British Gliding Association Aircraft Modification

Mandatory

Number: 035/02/2003	Issue: 1
------------------------	-------------

- Subject: Safety modifications to flight control systems
- Applicability: Aviastroitel Me7 and AC4 series all serial numbers
- Accomplishment: Part 1 and 2 – Before next flight

Figure 1

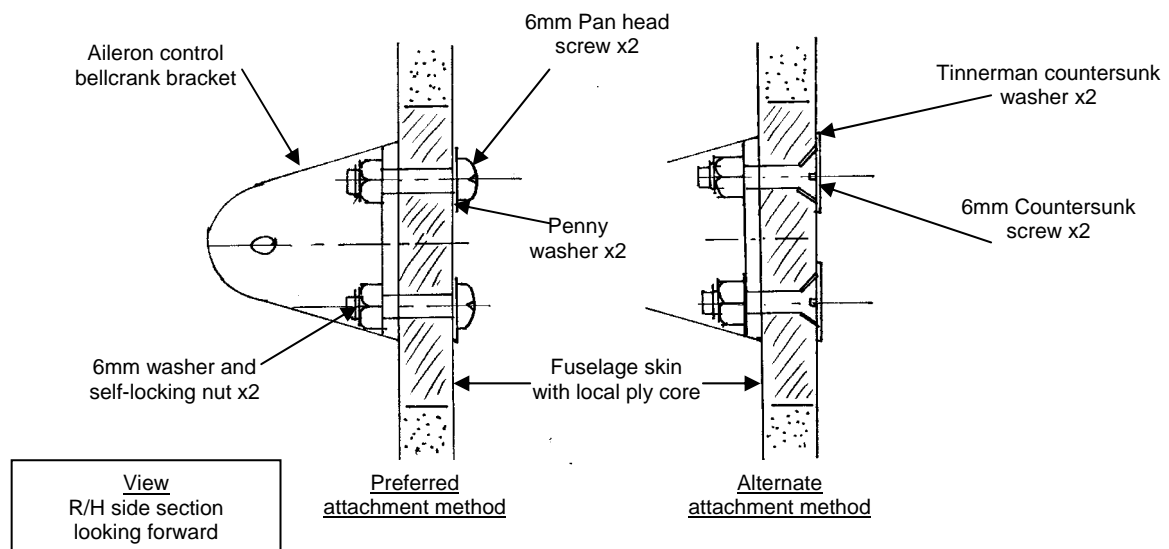
Attachment of Aileron Bellcrank bracket located in centre section fuselage R/H side.

1. Remove bellcrank pivot bolt and withdraw bellcrank to provide access to bracket attachment screws.
2. Remove upper and lower attachment self-tapping screws.

3. Drill 6mm holes for attachment bolts. It is recommended that an assistant hold a suitable piece of wood against the fuselage external skin to prevent drill break out when drilling through the outer gel coat.

4. Install suitable aircraft grade 6mm pan head screws with an 18mm o/d min. penny washer under the head from the outside. Install plain washers and new self-locking nuts on the inside. Ensure inside washers are clear the remaining self-tapping screw head, scallop washers if necessary. All hardware used must be of aircraft grade steel and plated.

5. Tighten sufficiently to secure but not so that the composite structure is crushed. 1½ complete threads must protrude through the nut.
6. Refit bellcrank and any other components removed for access.

- The 6mm pan head screws may be replaced with a hex head bolts.
- The 6mm pan head screws may be replaced with a 6mm countersunk screws provided that a tinnerman type countersunk washer is also used in place of the outside penny washer.

- The countersunk washer must be at least 18mm o/d and have the same angle countersink as the screw (90° or 100°). A suitable countersink tool will also be required. It is permissible to locally manufacture a countersunk washer. The purpose of the washer is to spread the load over a larger area and prevent indentation of the screw head.

- When countersinking the composite skin ensure that only the minimum amount of material is removed to accept the screw and countersunk washer.
- Trim finishing countersunk washers are not acceptable. Only flat tinnerman or solid washers are to be used.

Figure 2

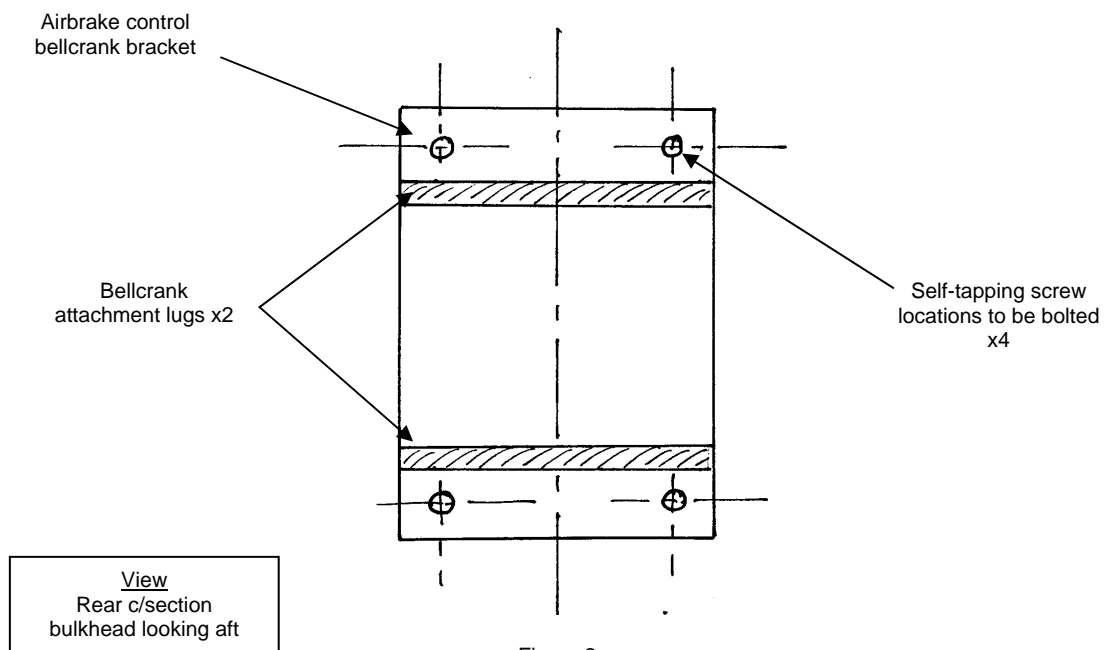
Attachment of Air Brake bracket located on centre section rear bulkhead forward face.

1. Remove vertical pivot bolt on air brake bellcrank and withdraw bellcrank if necessary.
2. Remove the 4 corner retaining self-tapping screws.
3. Drill 5mm holes for the attachment bolt in the original self-tapping screw locations. If possible, hold a piece of wood against the rear face of the bulkhead to prevent drill break out and give a clean hole through the laminate.
4. Install a 5mm hex bolt with plain washer on the forward face and install an 18mm o/d min washer and new self-locking nut on the rear face at each of the four positions. All hardware used must be of aircraft grade steel and plated.
5. Tighten nuts sufficiently to secure but not so that the composite structure is crushed. 1½ complete threads must protrude through the nut.
6. Refit removed airbrake bell crank and any other removed components.
7. Carry out duplicate inspection of refitted airbrake controls.

- It is permissible, as access to the rear of the bulkhead is very restricted, to install the bolts from the rear.
- 6mm bolts may be used provided that minimum hole edge margins are maintained.
- Any previously installed hardware that does not comply with the minimum requirements as stated above may only continue to be used after approval from the CTO.

Figure 3

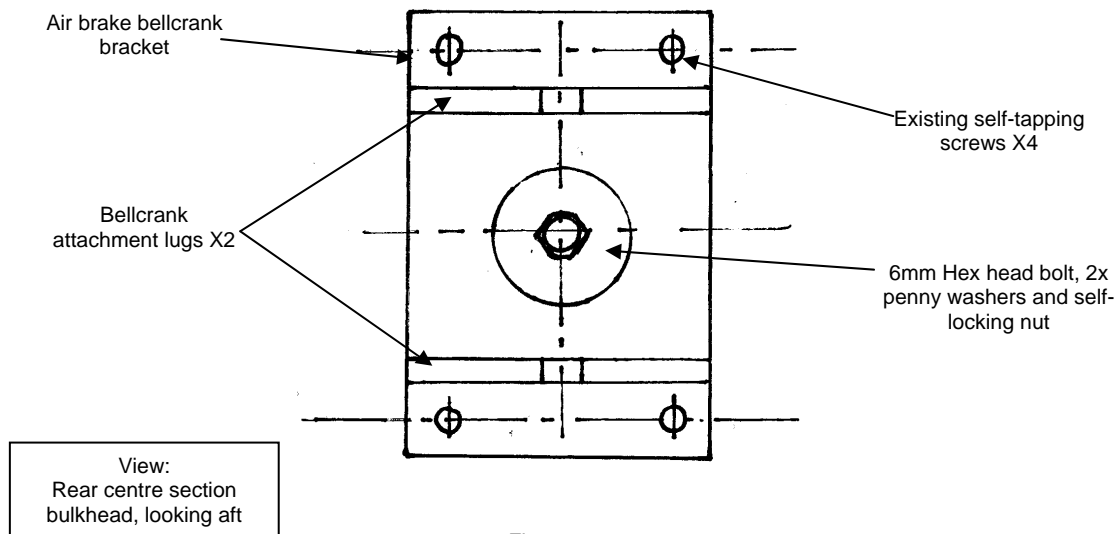
Attachment of Air Brake bracket located on centre section rear bulkhead forward face.

1. Remove vertical pivot bolt on air brake bellcrank and withdraw bellcrank. To gain sufficient access the bellcrank may have to be removed completely.
2. Mark the centre of the bracket midway between the two lugs and centrally between the edges.
3. Drill 6mm hole for the attachment bolt. If possible, hold a piece of wood against the rear face of the bulkhead to prevent drill break out and give a clean hole through the laminate.
4. Install a 6mm hex bolt with 18mm o/d penny washer and install an 18mm o/d penny washer and new self locking nut. All hardware used must be of aircraft grade steel and plated.
5. Tighten nut sufficiently to secure but not so that the composite structure is crushed. 1½ complete threads must protrude through the nut.
6. Refit removed airbrake bell crank and any other removed components.
7. Carry out duplicate inspection of refitted airbrake controls.

- It is permissible, as access to the rear of the bulkhead is very restricted, to install the bolt from the rear.
- Any previously installed hardware that does not comply with the minimum requirements as stated above may only continue to be used after approval from the CTO.
